ADMINISTRATIVE ADJUSTMENT OF STANDARDS Neighborhood Street Standards in Talus

PROJECT: Middle School No. 6 (Talus)

PERMIT NUMBER: AAS20-00002 for SDP19-00002, PRJ18-00020

DATE OF DECISION: January 31, 2020

Figure 1. Excerpt from Sheet C601, Paving and Horizontal Control Plan – North, showing proposed modifications to Falcon Way NW.

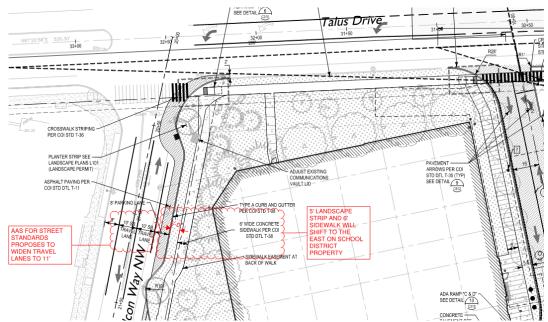
The proposal achieves the intent of the Talus Replacement Regulations and CIDDS by widening the travel lanes by only 1 ft. beyond the standard travel lane width to balance keeping the road as narrow as possible while addressing functionality. Automobile speeds are addressed below.

<u>Response:</u> The proposed travel lane width increase for a limited distance would ensure greater clearance for school buses to access Falcon Way without likely encouraging increased automobile speeds due to the proposal's limited length.

The following adjustment is approved with conditions:

- 1. Unless otherwise specified, the adjustment shall be subject to all plans, specifications, and conditions set forth in the application.
- 2. No Talus Replacement Regulations or Issaquah Municipal Code regulations are modified by this design unless specifically identified through this Administrative Adjustment of Standards for auto inclusive circulation facilities standards.
- 3. This decision only applies to the Request.

C601

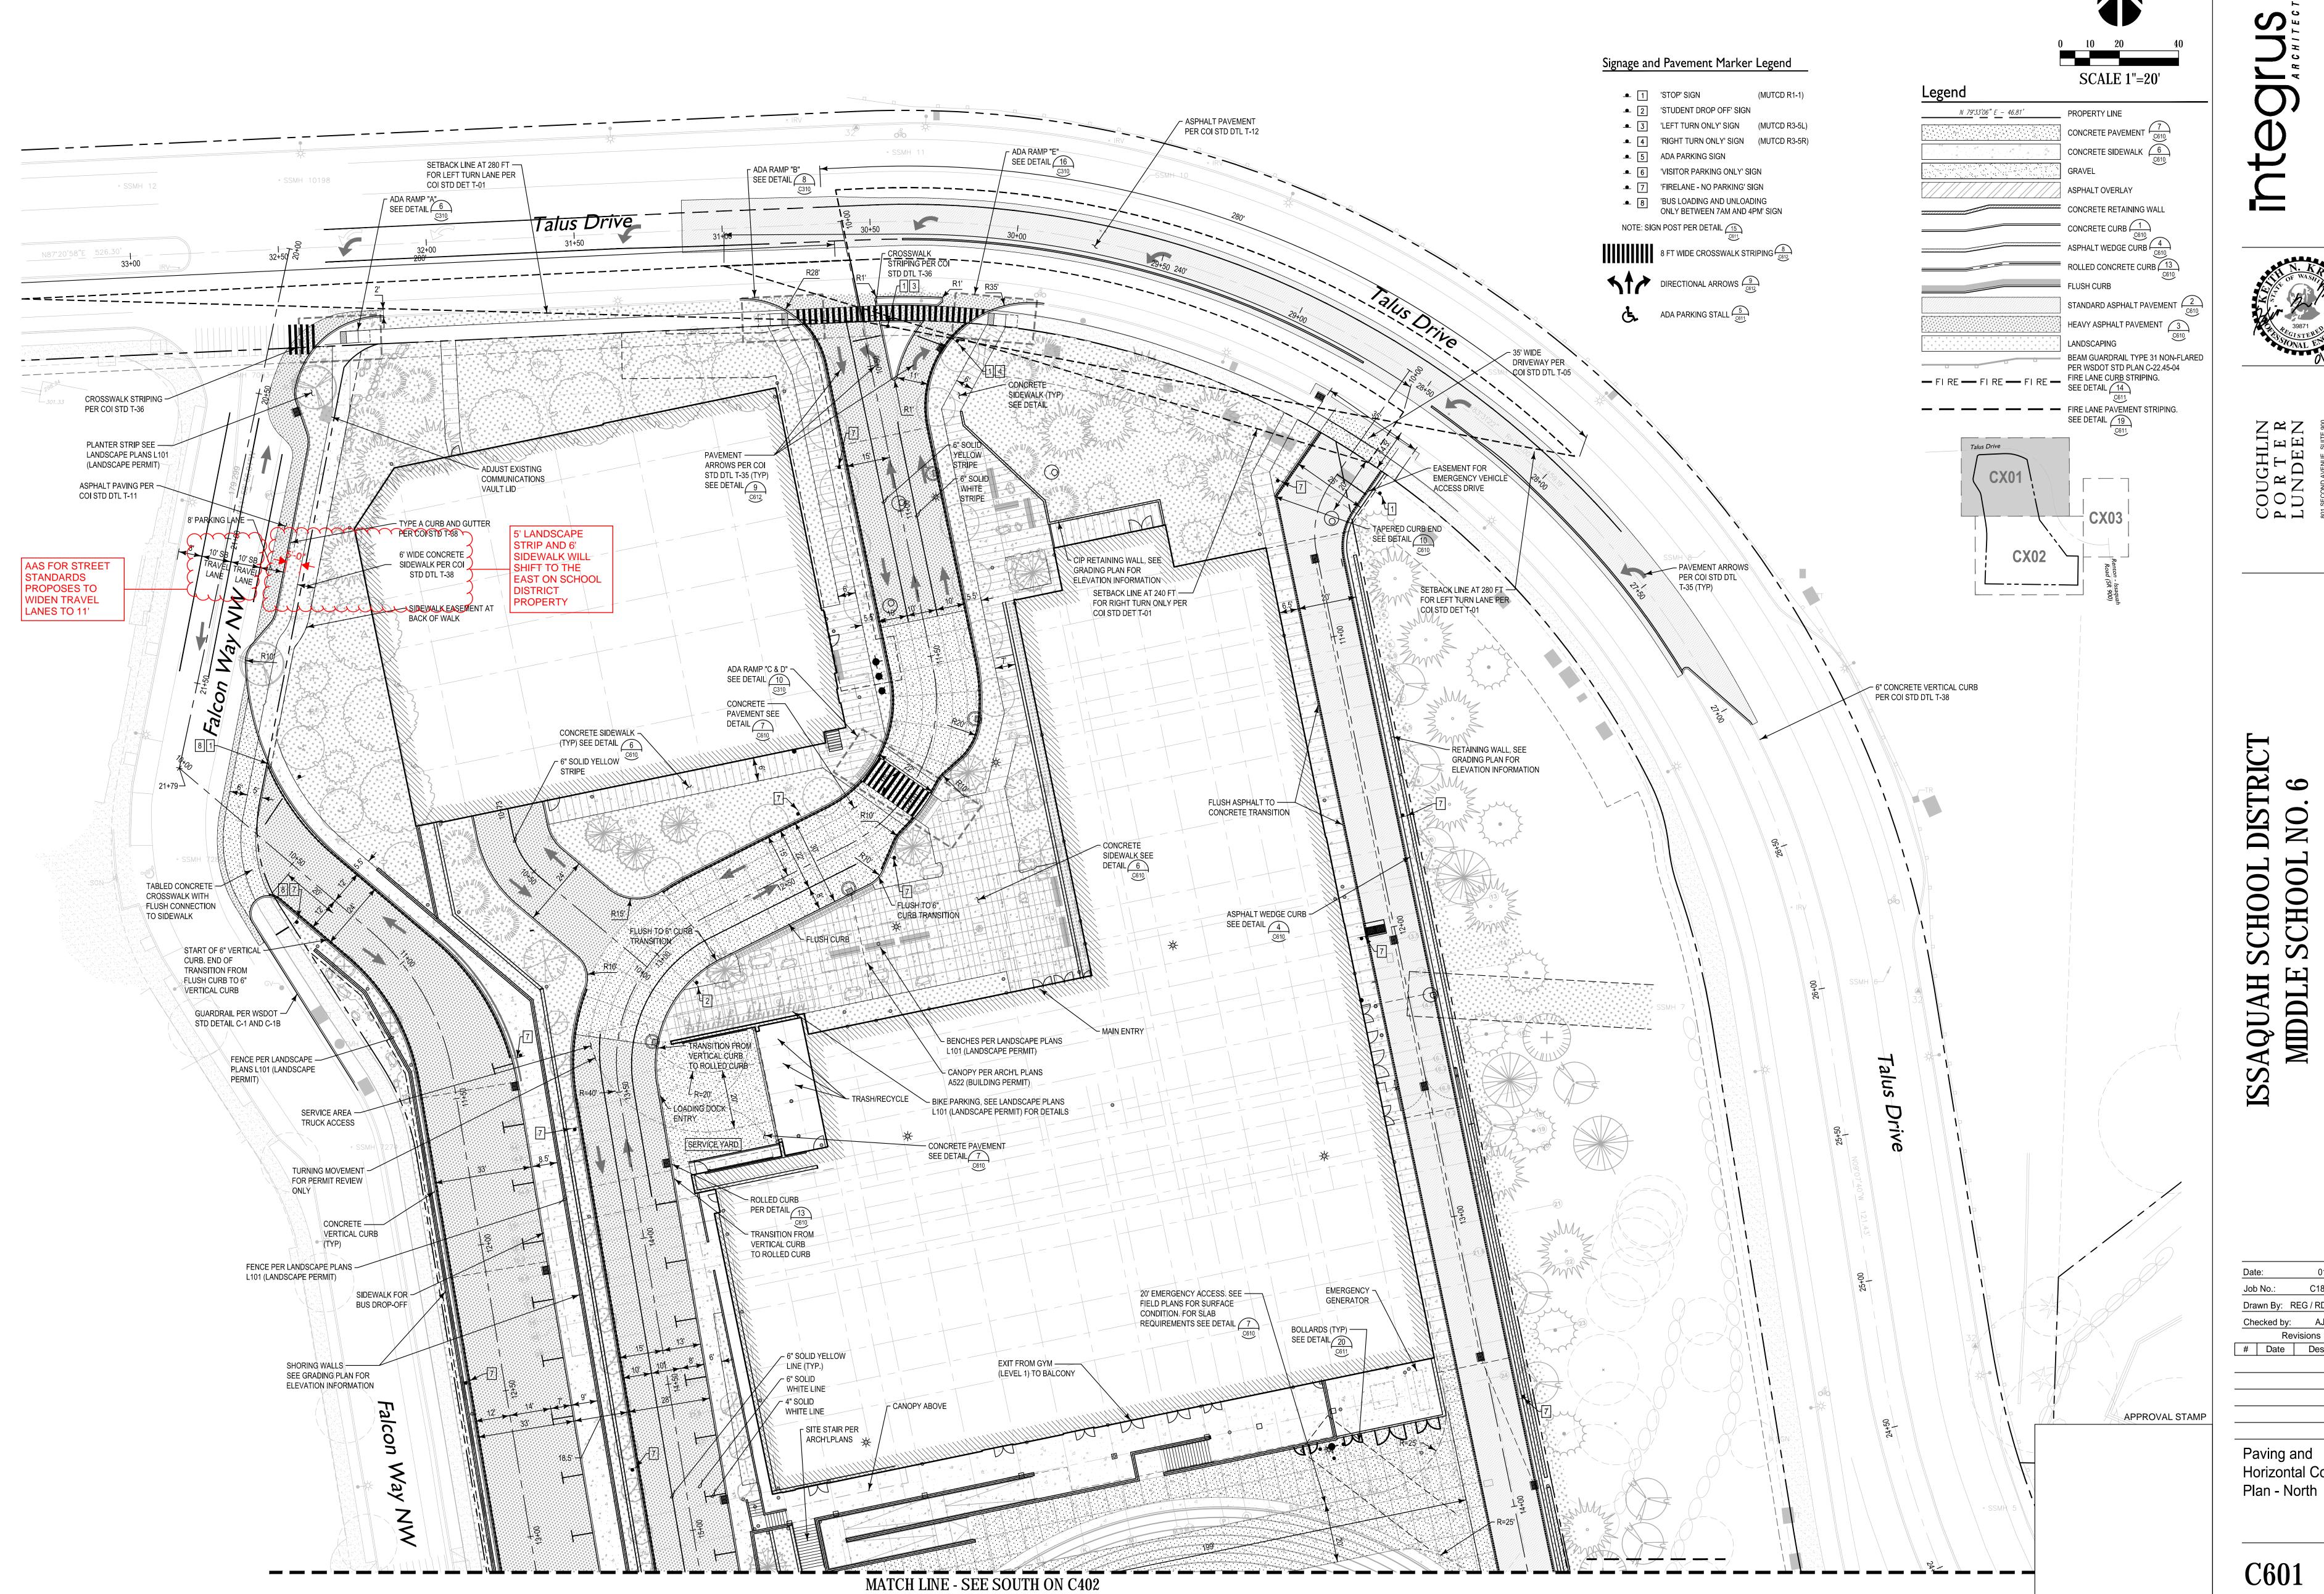
The current condition of Falcon Way NW does not meet the standards of Central Issaquah Area Development and Design Standards, Chapter 18.19A, 6.0 Circulation Facilities, 6.4 E. Auto Inclusive Circulation Facilities: Neighborhood Street. The proposed development intends to improve Falcon Way for approximately 160'-0" from the intersection at Talus Drive to the proposed Bus Lane driveway. The improvement would include providing a 6'-0" sidewalk and a 5'-0" Landscape Strip on the east side of Falcon Way, 8'-0" wide parallel parking lanes on both sides and 2 – 11'-0" Travel Lanes.

- 1. Vision. The proposal is superior in achieving the intent of the Central Issaquah Plan, Development Design Standards by providing sidewalk and landscape widths equal to the minimum required for Neighborhood Streets (on the east side of Falcon Way) and widening the travels lane to 11'-0" each, which is 1'-0" wider than the minimum required for Neighborhood Streets

- **4. Sufficient Reason.** The proposed travel lane width increase is to provide greater clearance for the school buses access onto Falcon Way and to not disrupt the existing neighborhood traffic.
